TITLE: **PRELIMINARY PLAT NO. 02017, VINTAGE HEIGHTS 3RD ADDITION**, requested by Engineering Design Consultants on behalf of Hampton Development Services, for approximately 182 lots, with requests to waive lot frontage, lot depth-to-width ratio and sidewalks on the south side of Venice Court, on property generally located at South 91st Street and Pine Lake Road.

Re: Preliminary Plat No. 02017
VINTAGE HEIGHTS 3RD ADDITION

P.A.S.: Vintage Heights 3rd Addition
Annexation #02009
Change of Zone #3374
Special Permit #1762A
Preliminary Plat #02017

SITE
PLAN

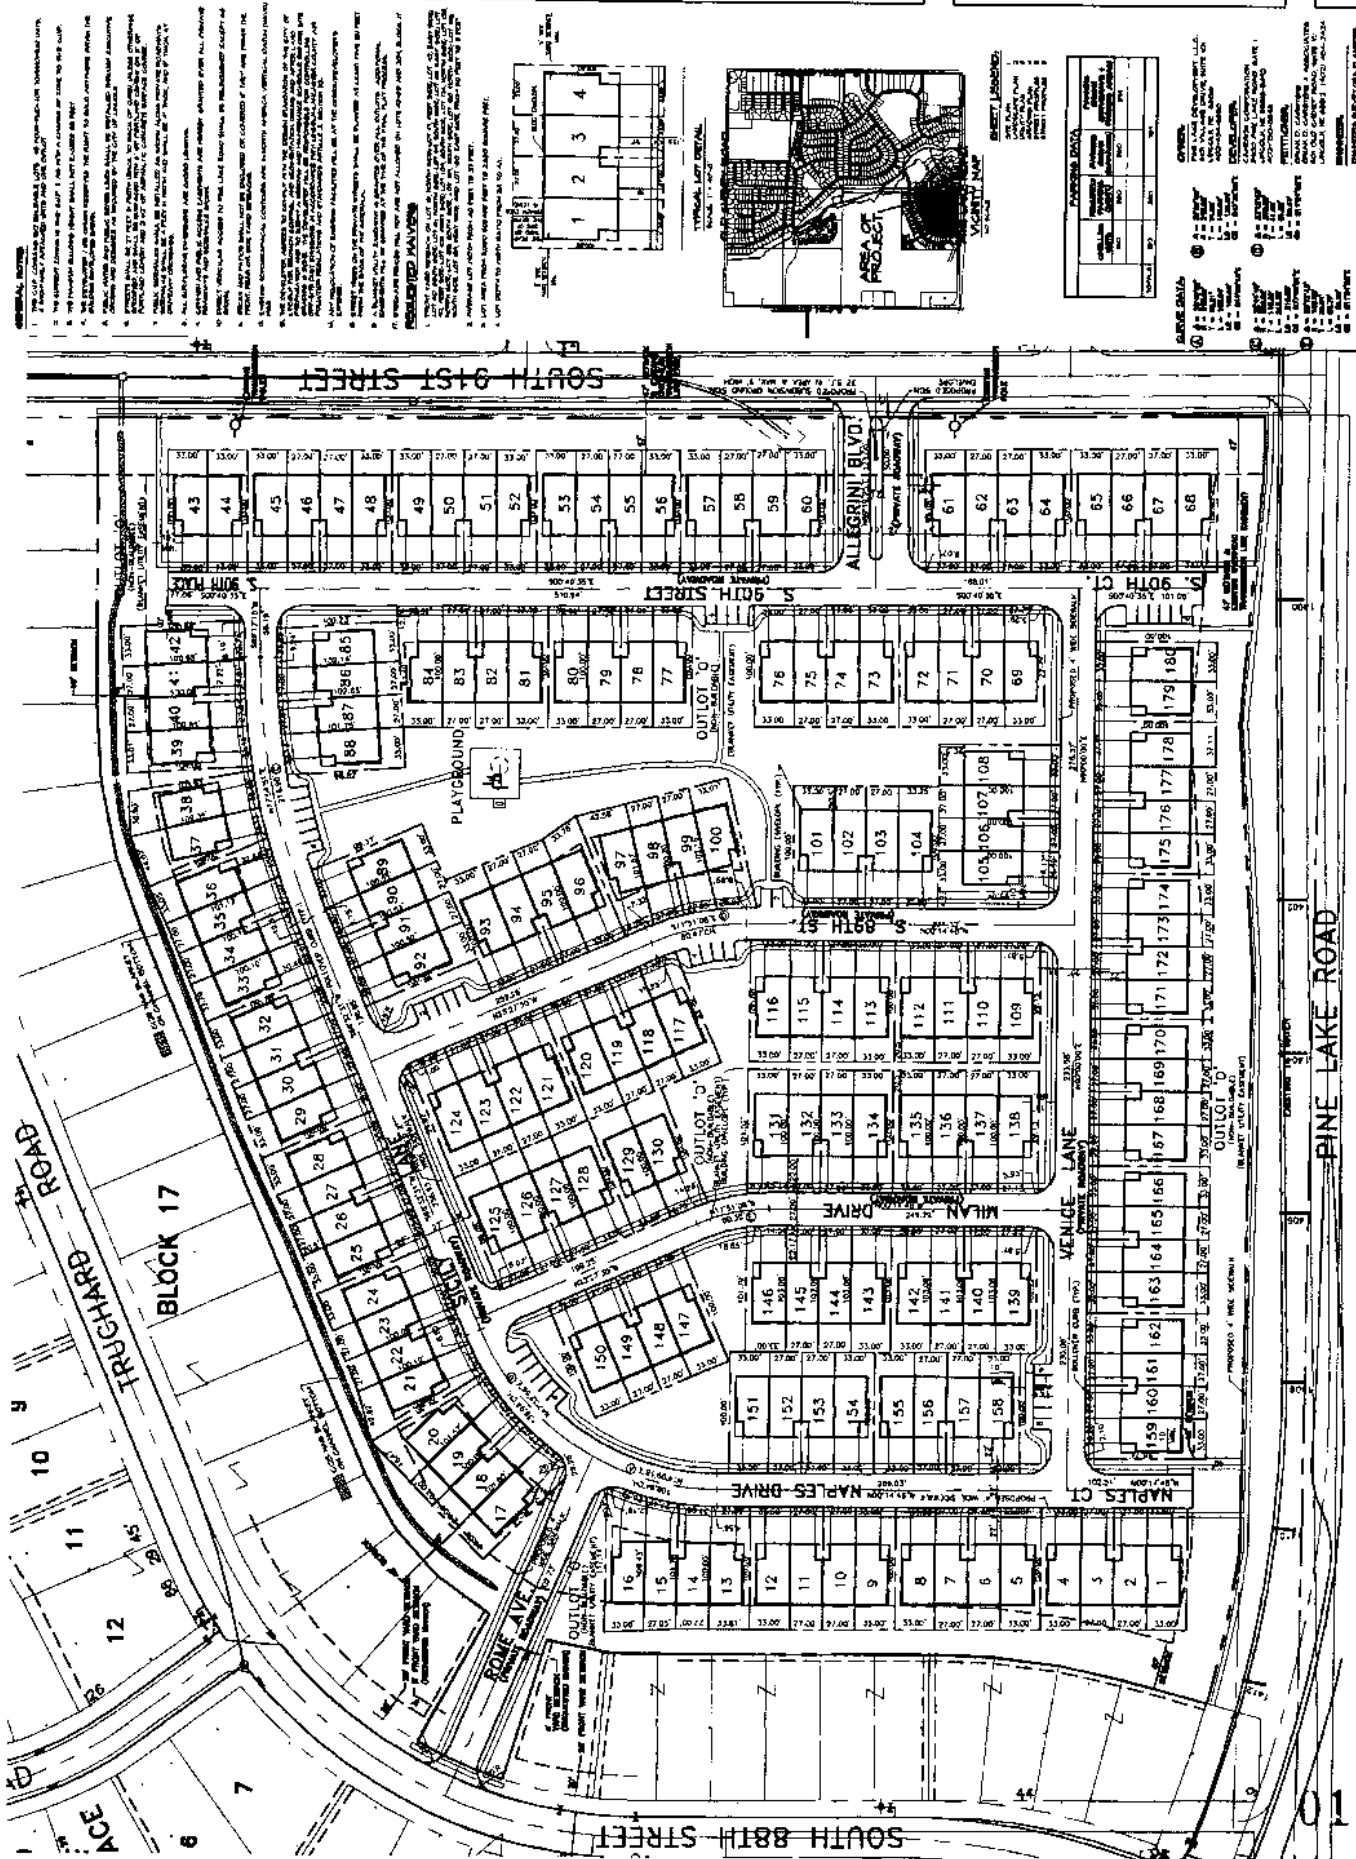
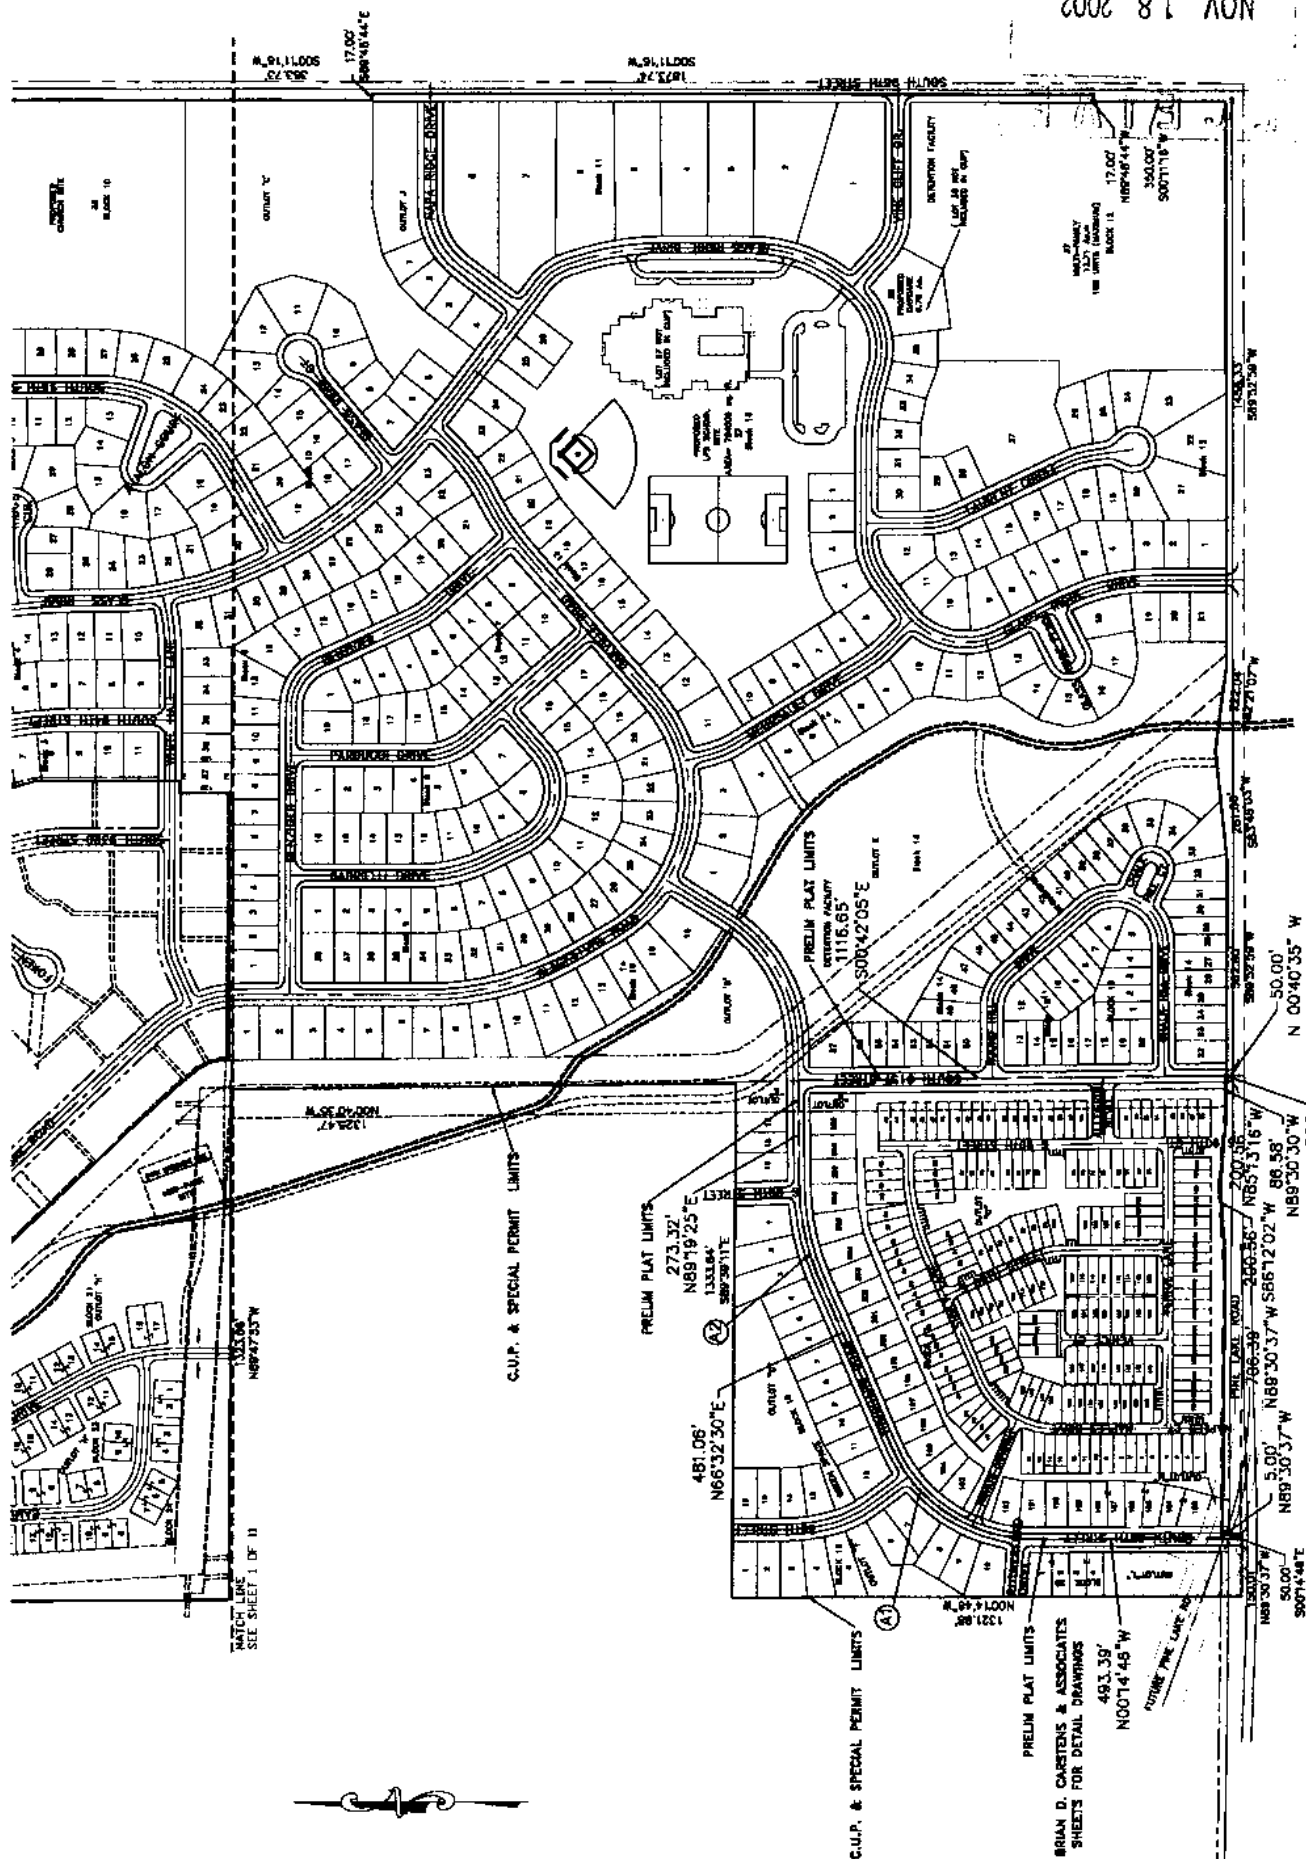
- 1.1 Revise the preliminary plat to show:
 - 1.1.1 Block 17(Sheet 1 and 2 of 11) consistent with the larger site plan for Allegrini Terrace(Sheet 1 of 6).

3. The grading information provided in the NE corner of the plat is unsatisfactory. The plan shows grading a 30' wide swale over the storm sewer in the 91st Street right-of-way. Grading and sidewalk grades in S 91st Street will not be altered. Without the regrading of the right-of-way, it appears that lots to the north will be flooded in the 100 year event. This is unsatisfactory.

6. The north-south portion of Venice Court as it intersects the east-west portion is in violation of the platform requirement and must be revised. Venice Court does not have a permanent turn around as per subdivision ordinance requirements.

7. Venice Court has been modified to a pavement width of 27 feet on the piece running north/south. The hammerhead of Venice Court is shown with 21 feet wide pavement since there are only 4 units that access the roadway.
